LYDIA LEIS ADDITION TO SEDGWICK COUNTY, KANSAS

RE: SUB 2002-67 -- One-Step Final Plat of Lydia Leis Addition

RE: SUB 2002-67 -- One-Step Final Plat of Lydia Leis Addition

CASE NUMBER: SUB 2002-67 -- LYDIA LEIS ADDITION

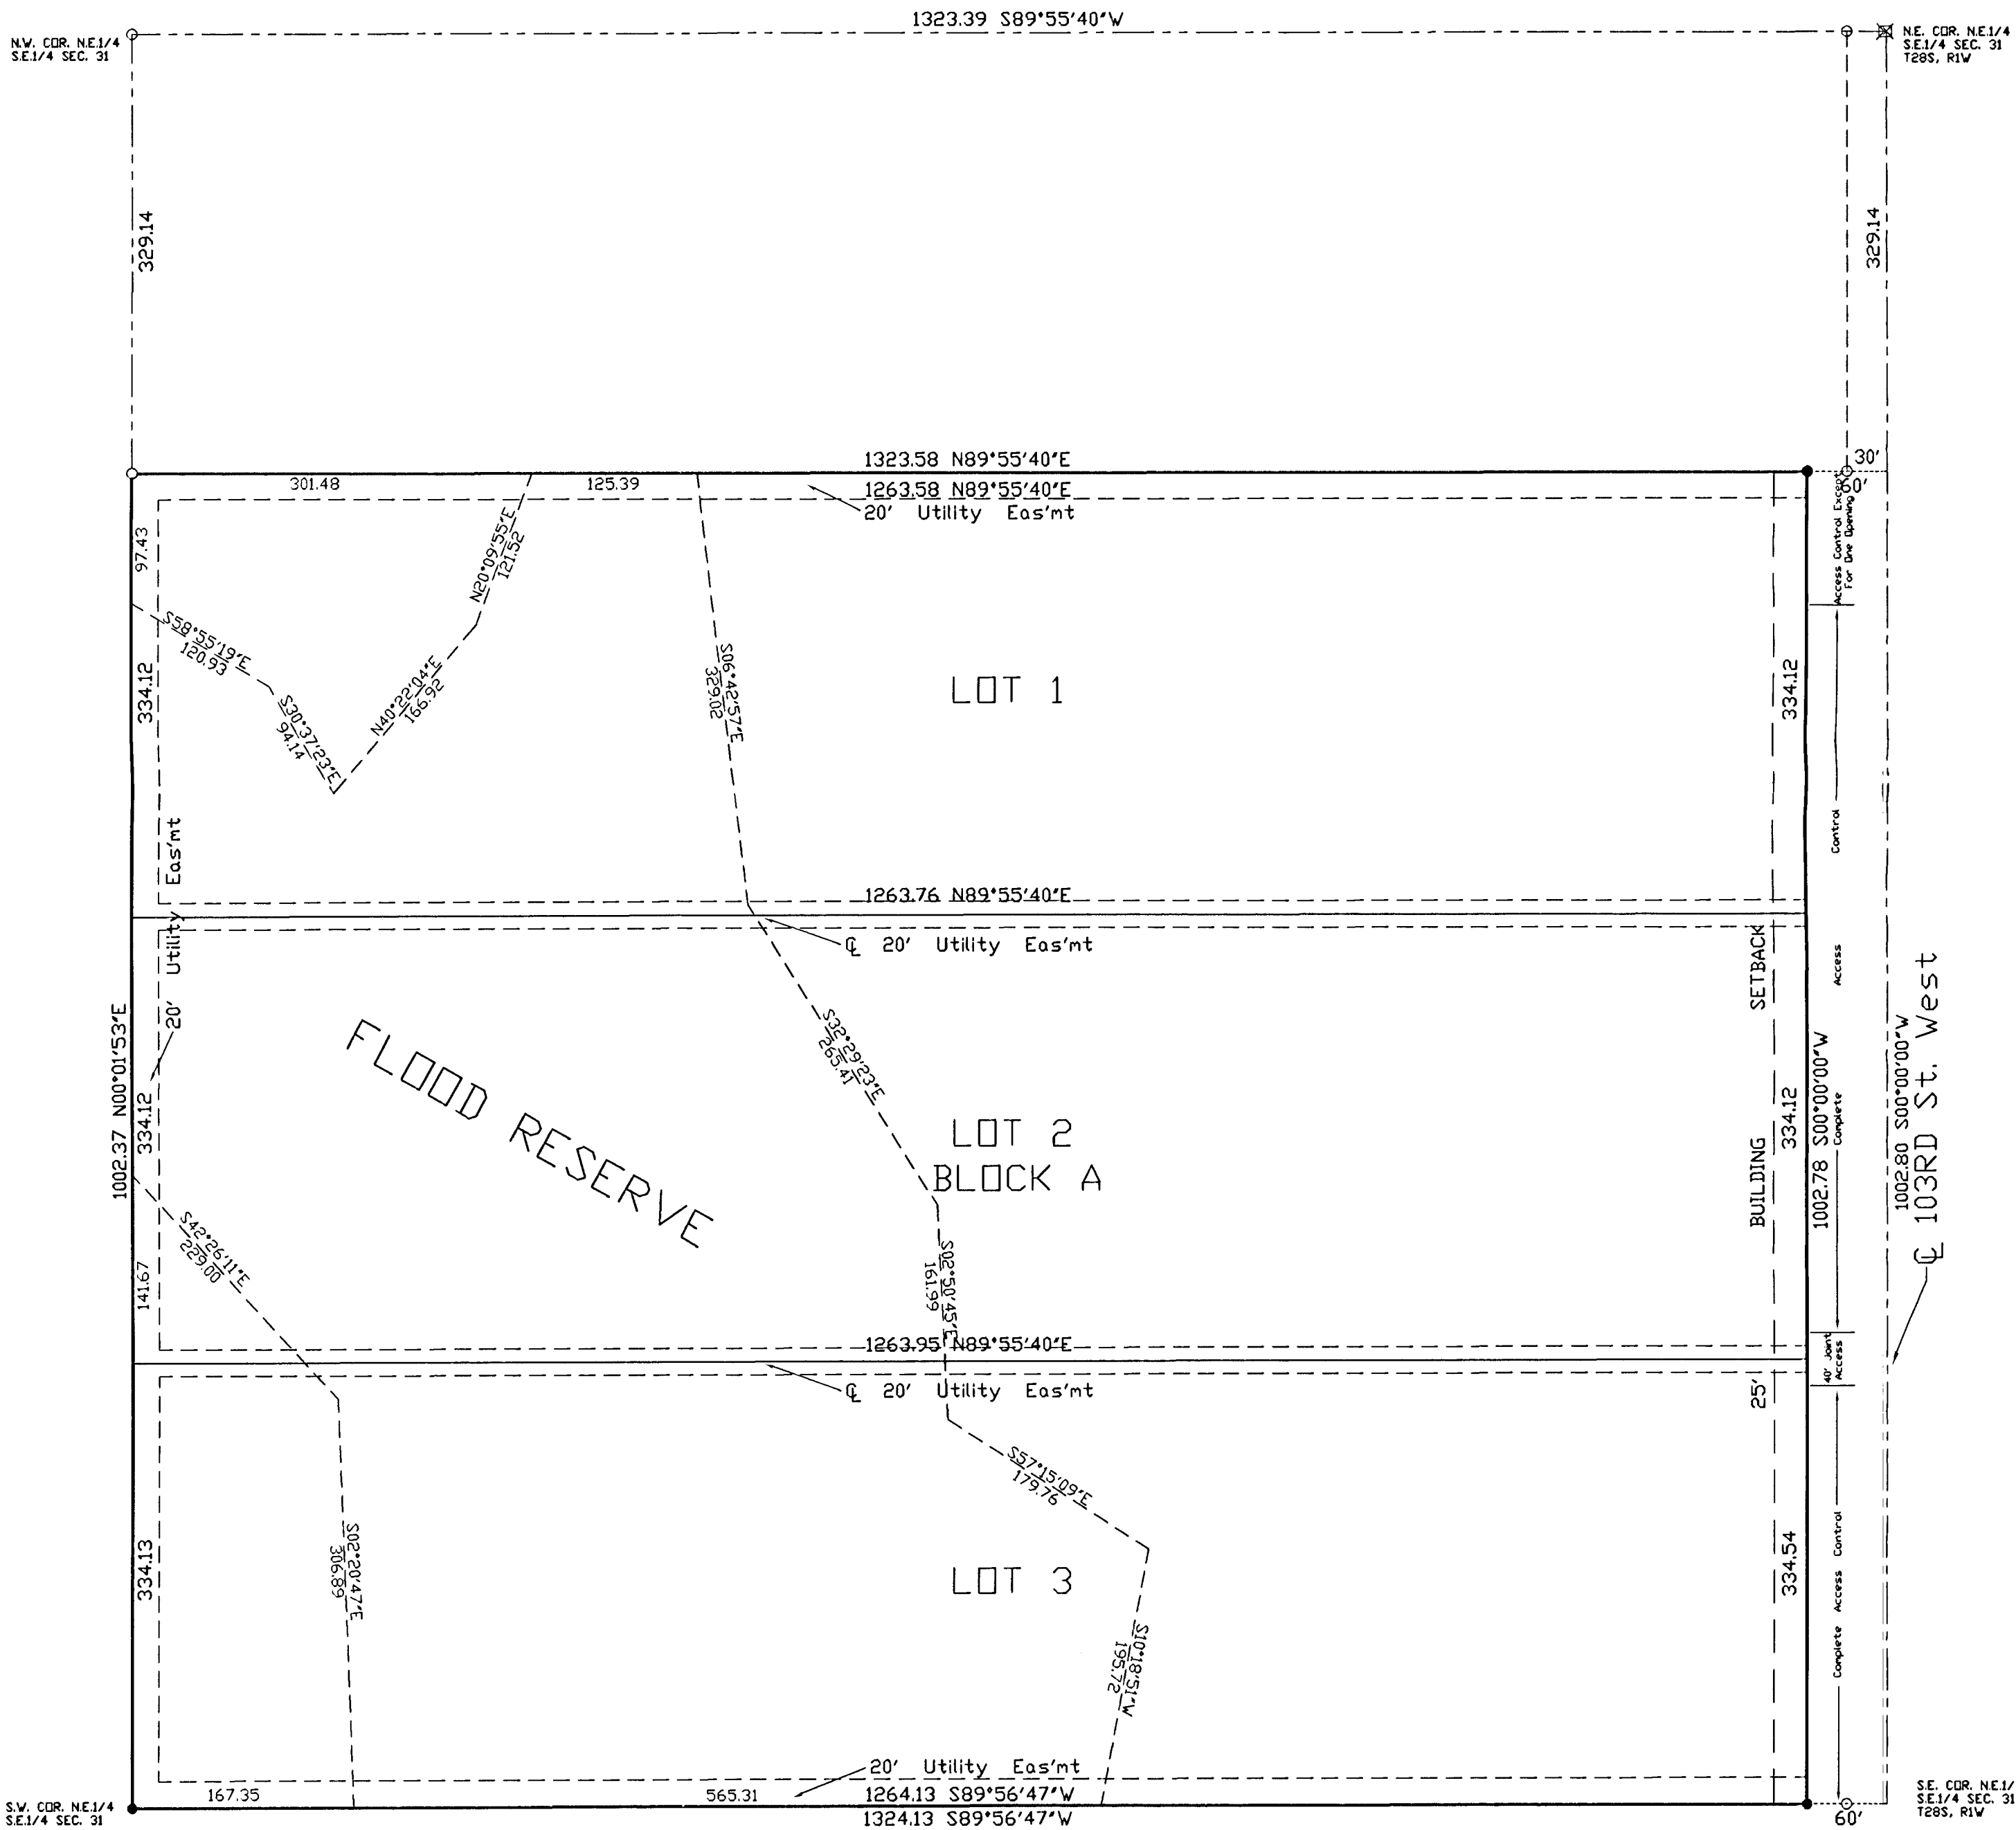
- D. **County Engineering** needs to comment on the status of the applicant's drainage plan. **A drainage plan is needed. A floodway reserve needs to be platted.**

- E. **County Engineering** needs to comment on the access controls. The plat proposes two access openings along 103rd St. West, including one joint opening between Lots 2 and 3. **Two openings have been approved. The opening for Lot 1 shall be located along the north property line.**

- H. On the final plat tracing, the MAPC signature block needs to reference "J.D. Michaelis, Chair".
- I. The signature line for the County Commissioners Chairman needs to reference "Ben Sciortino".

- J. The Applicant is advised that if platted, the building setbacks may be reduced to 25 feet to meet the 85-ft setback required from the centerline of County section line roads.

- K. Approval of this plat will require a waiver of the lot depth to width ratio of the Subdivision Regulations for all three lots. The Subdivision Regulations state that the maximum depth of all residential lots shall not exceed 2.5 times the width.

- L. The plat's text shall include language that a drainage plan has been developed for the plat and that all drainage easements, rights-of-way, or reserves shall remain at established grades or as modified with the approval of the applicable City or County Engineer, and unobstructed to allow for the conveyance of stormwater.
